Amended
Architectural Review Board Agenda
4:00 PM Tuesday, July 8, 2025
Sussex Civic Center – Committee Room Second Floor

MEMORANDUM

TO: Architectural Review Board
FROM: Gabriel Gilbertson, Community Development Director
RE: May 7, 2025 Architectural Review Board
DATE: Friday, June 27, 2025

- I. **Roll call.**
- II. **Consideration and possible action on the ARB minutes of April 2, 2025.**
- III. **Discussion and possible action on a Plan of Operation, site plan, landscape plan, architecture plan, and lighting plan for Scooter's Coffee located at the southwest corner of Business Dr and State Highway 164.**

EXTERIOR
ELEVATIONS

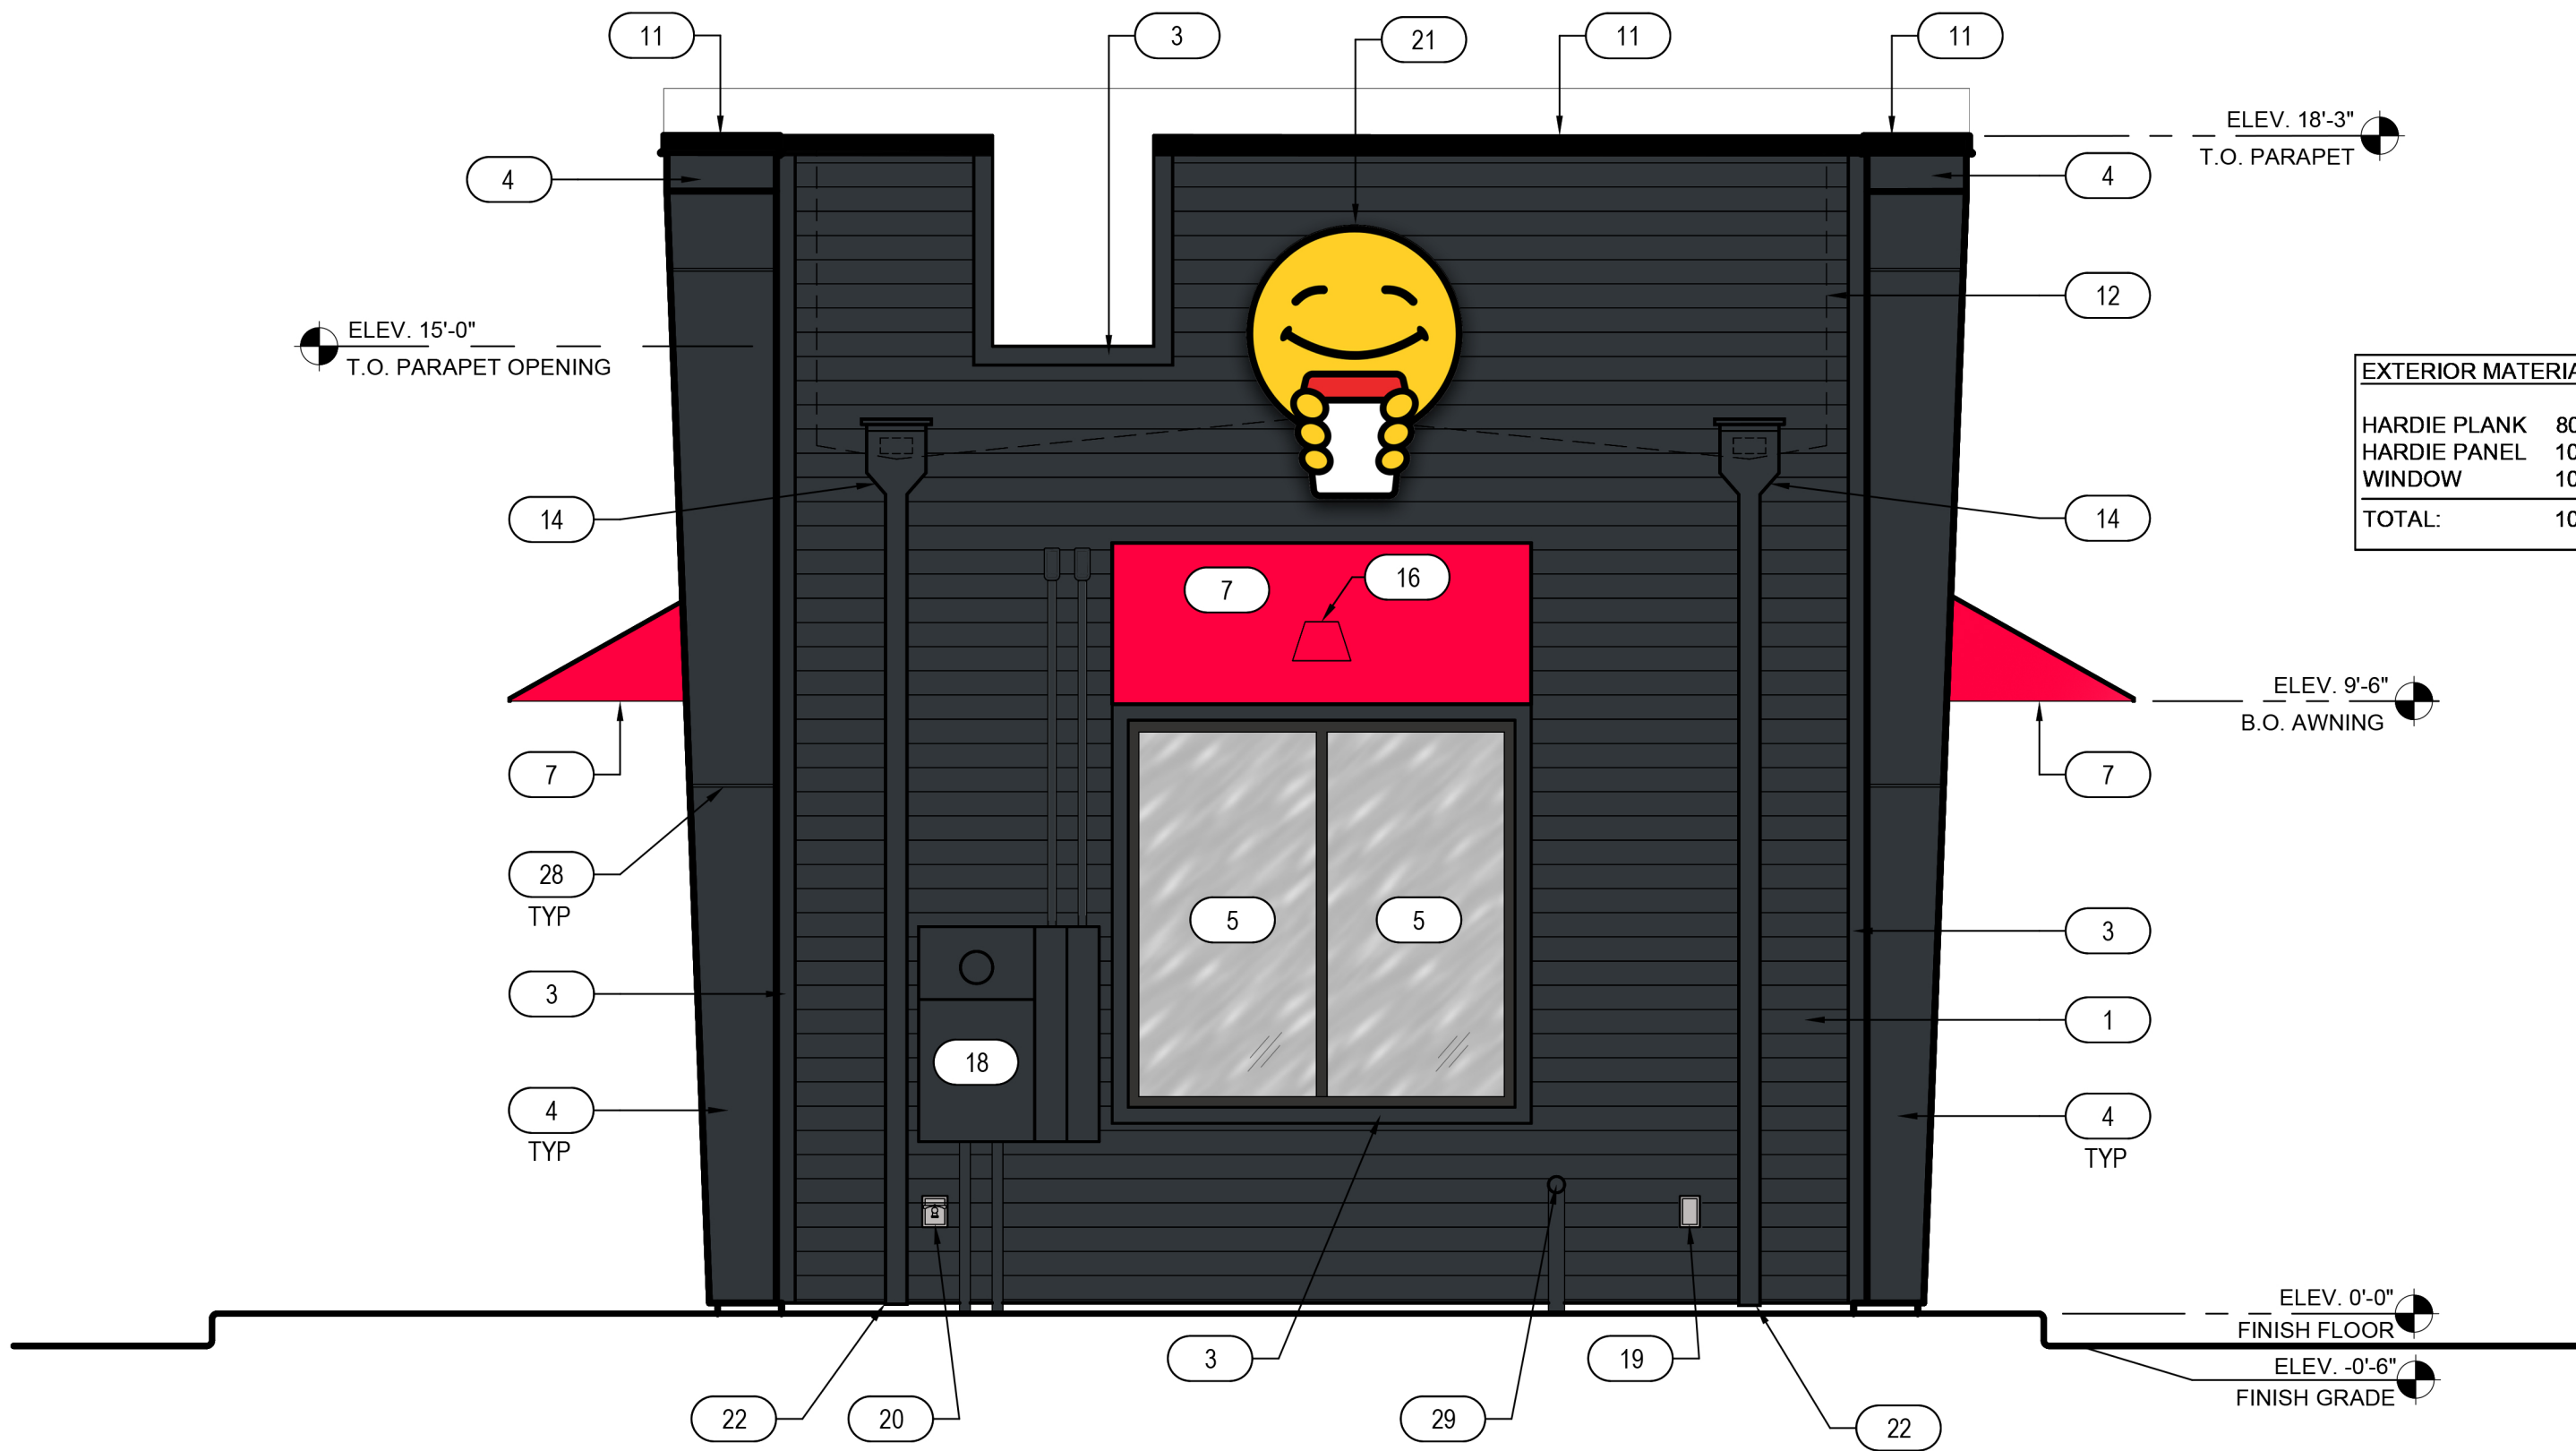
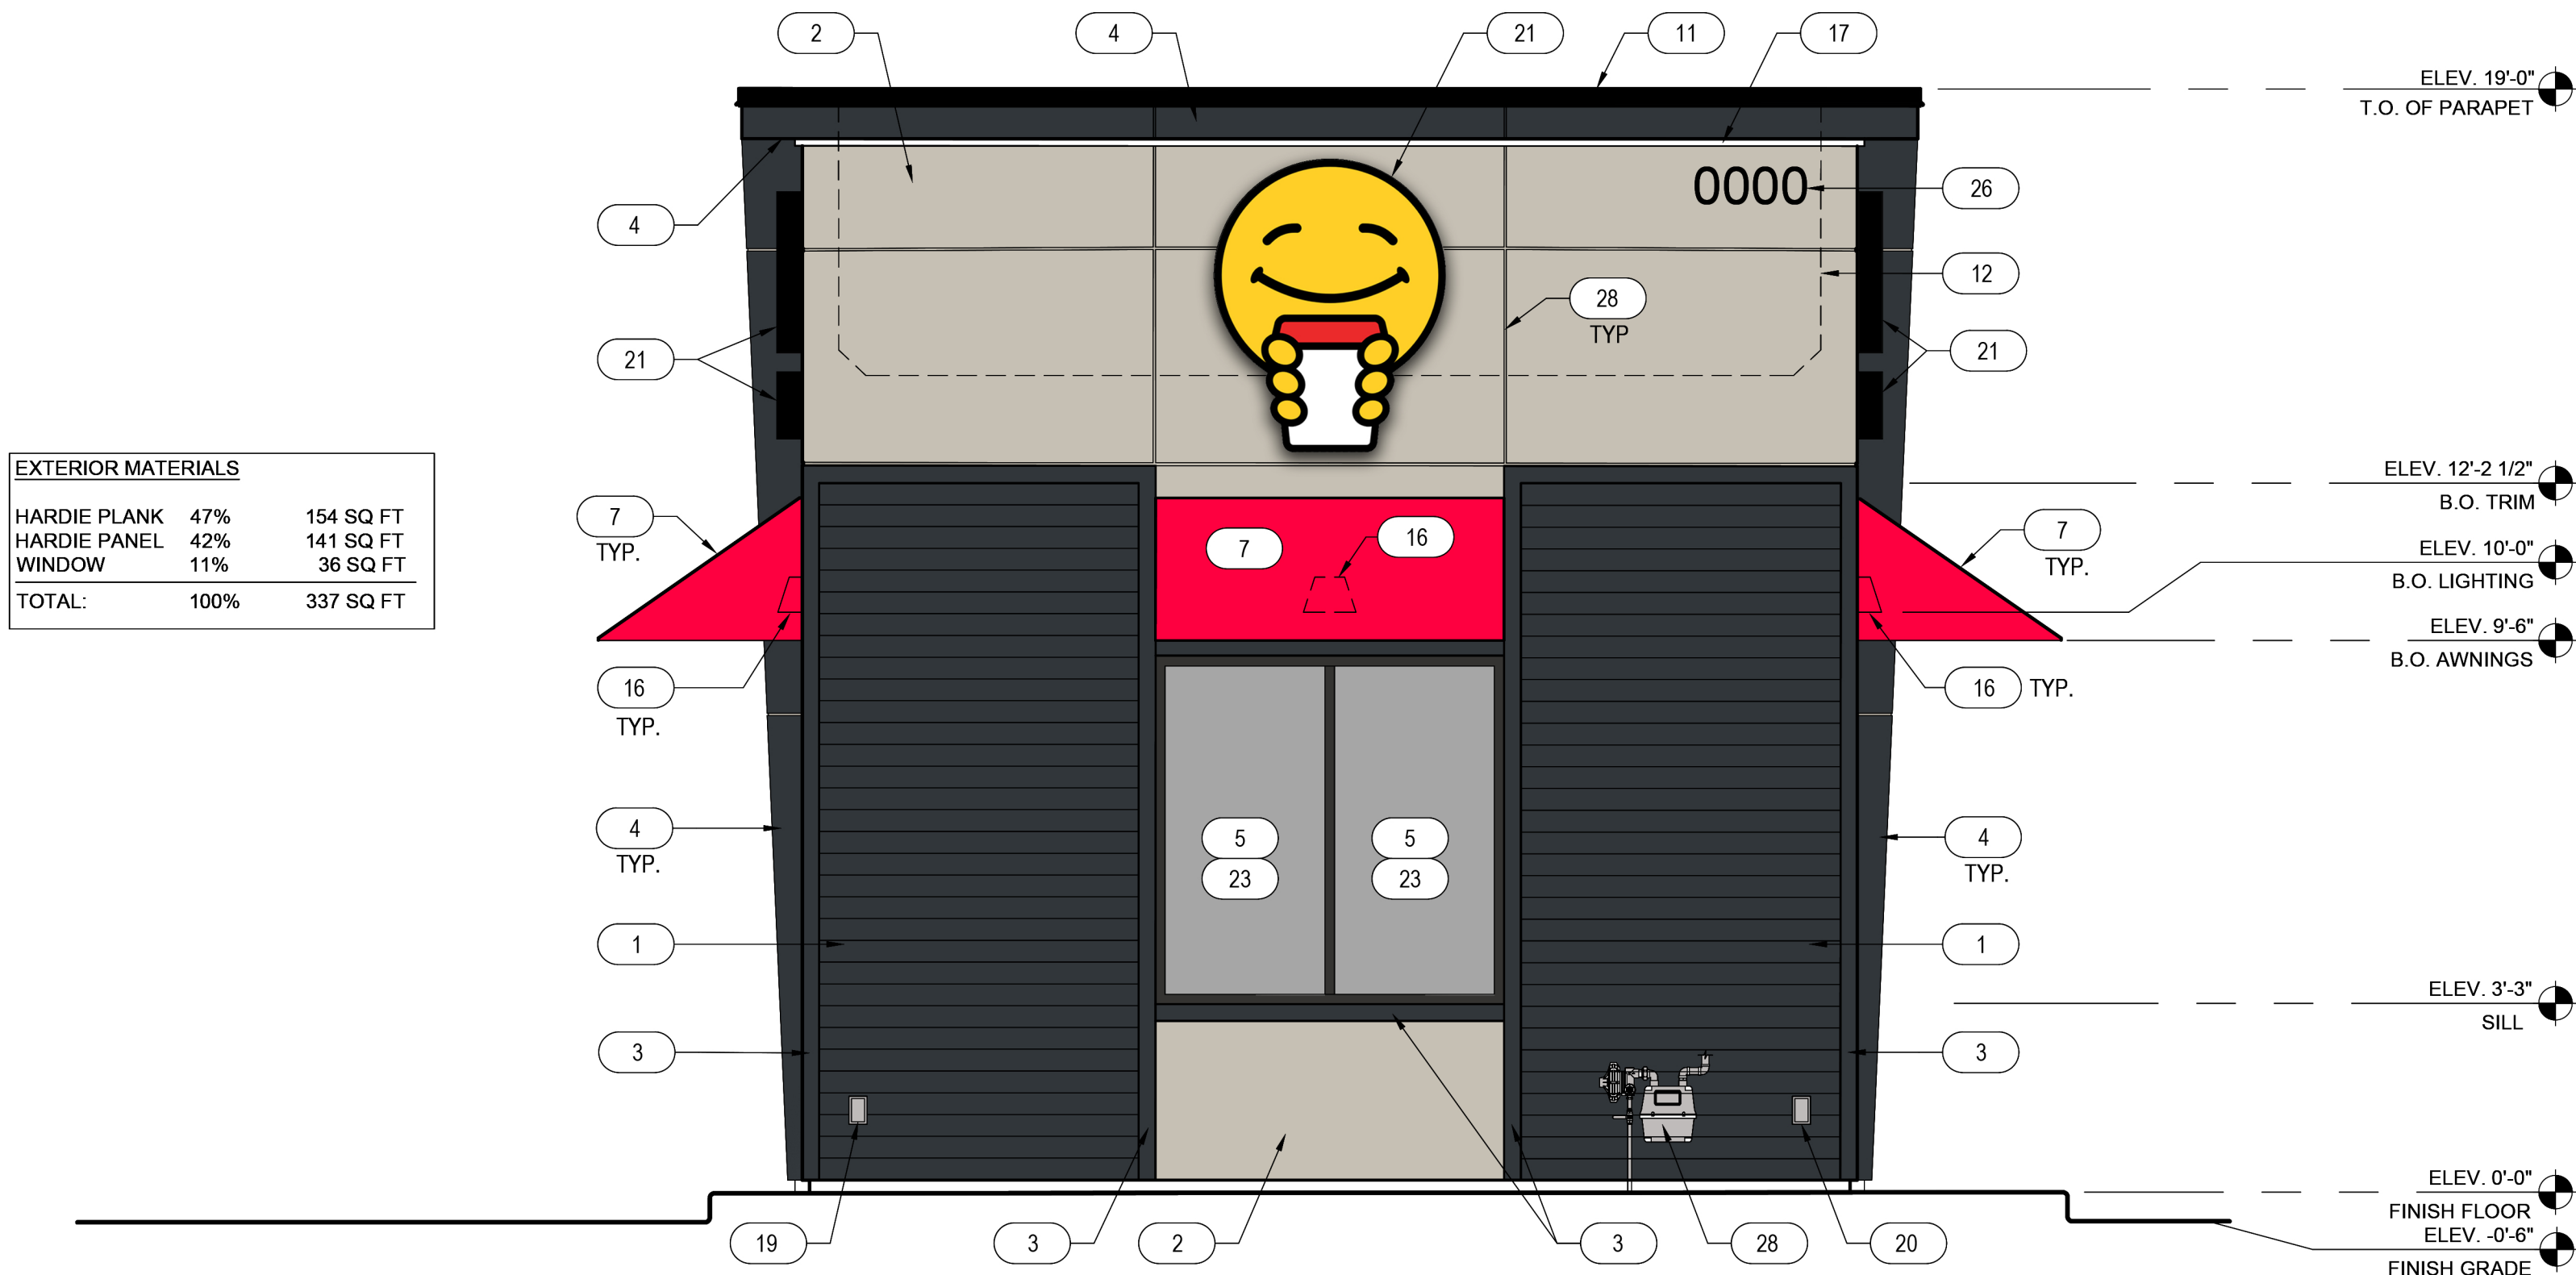
- Building meets height and required setbacks.
- Roof top units are to be screened from view.
- Materials to be used meets the Design Standards.
- Revised elevations that meet 33% window and door openings are required.

1. Submitting a revised landscape plan that meets the minimum requirements of the Sussex Design Guidelines.
2. Submitting a revised lighting plan that includes details for light fixture mounting height and pole bases.
3. Compliance with the comments and conditions of the Community Development Department in the memo dated May 28, 2025.
